Application for Variation of an Environmental Permit

C1. Name of the Current Environmental Permit Holder :
Drainage Services Department
C2. Application No. of the Current Environmental Permit : EP-456/2013/A
C3. The Current Environmental Permit was Issued in : month / year
03 / 2019

Environmental Review Report

Contract No. DPW 01/2020 Environmental Team for Drainage Improvement Works at Ngong Ping | VEP Application for Additional Jacking Pit

Figure:	A.2b	Rev:	1
Scale:	1 : 3000 (A3)

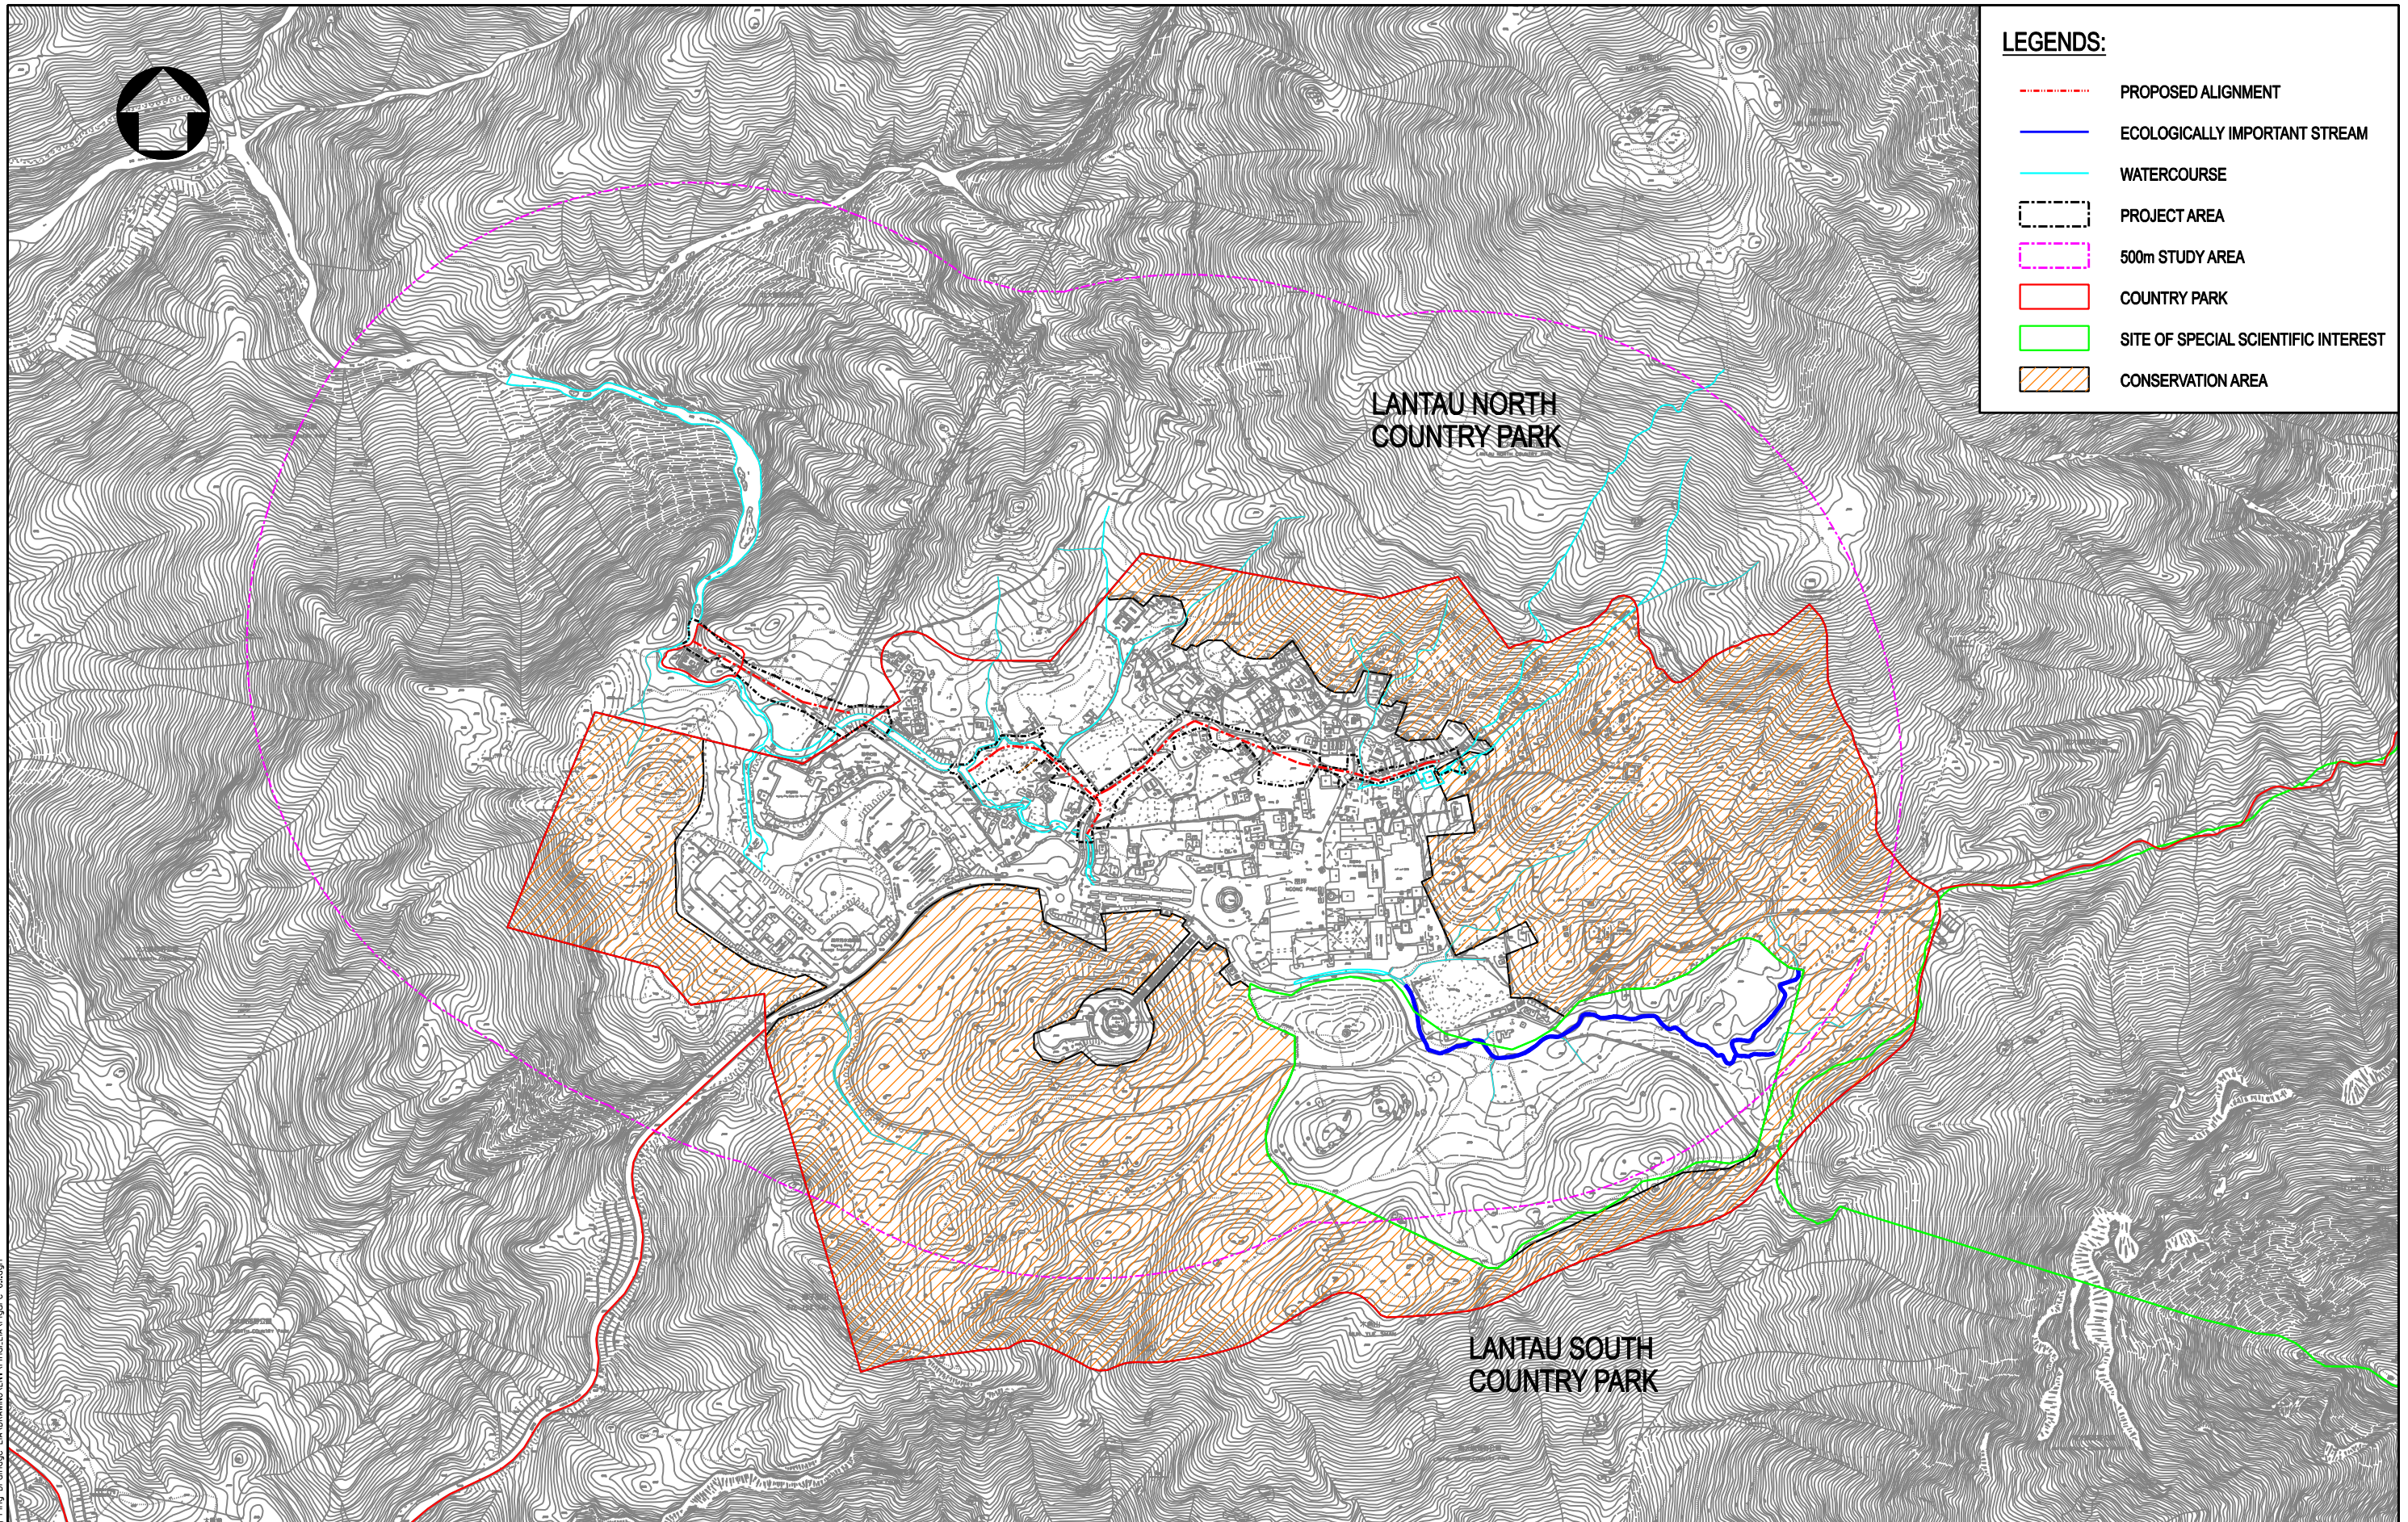
<p>D1. Condition(s) in the Current Environmental Permit :</p> <p>Figure 2: Works Sections</p>	<p>D2. Proposed Variation(s) :</p> <p>Refer to Section 2.4 of ERR, Figure 2 of the EP to be replaced with Appendix A.2b of the Environmental Review Report (ERR).</p>	<p>D3. Reason for Variation(s) :</p> <p>Refer to Section 1.2 of the ERR.</p>	<p>D4. Describe the environmental changes arising from the proposed variation(s) :</p> <p>Refer to Sections 3 to 9 of the ERR.</p>	<p>D5. Describe how the environment and the community might be affected by the proposed variation(s) :</p> <p>Refer to Sections 3 to 9 of the ERR.</p>	<p>D6. Describe how and to what extent the environmental performance requirements set out in the EIA report previously approved or project profile previously submitted for this project may be affected :</p> <p>As described in Sections 3 to 9 of the ERR, the environmental performance requirements set out in the previously approved EIA report will not be affected by the proposed variation.</p>	<p>D7. Describe any additional measures proposed to eliminate, reduce or control any adverse environmental impact arising from the proposed variation(s) and to meet the requirements in the Technical Memorandum on Environmental Impact Assessment Process :</p> <p>No additional mitigation measures will be required. As the proposed variations will not have implications on the validity of the findings of the approved EIA report, the proposed project still complies with the requirements in the Technical Memorandum on Environmental Impact Assessment Process.</p>
